Driver's Seat Squeaks or Squeals When Adjusted

AFFECTED VEHICLES

| Year | Model | Trim Level | VIN Range |
|------|------------|------------|--|
| 2019 | RDX 2WD | ALL | 5J8TC1...KL000001 thru 5J8TC1...KL023571 |
| | RDX SH-AWD | ALL | 5J8TC2...KL000001 thru 5J8TC2...KL038848 |

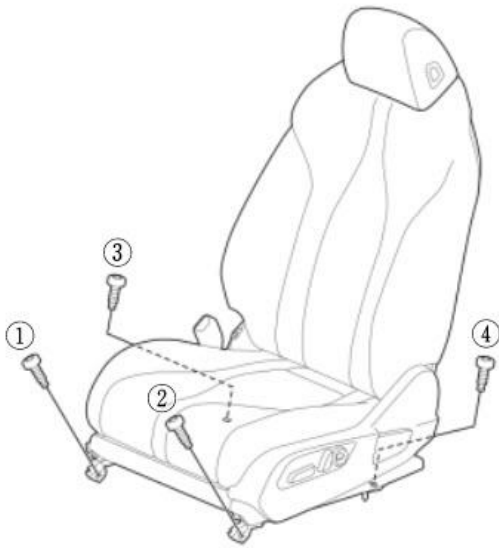
4. Route and secure the cable tie through the hole as shown. The cable tie must be above the shaft, toward the front of the vehicle, and to the right of the tab holding the rod.

Do not wrap the wire tie around the harness. Wrap it only around the flex shaft cover and the shaft.

Make sure the harness is not being secured by the wire tie.

Route the wire tie.

Secure the wire tie.
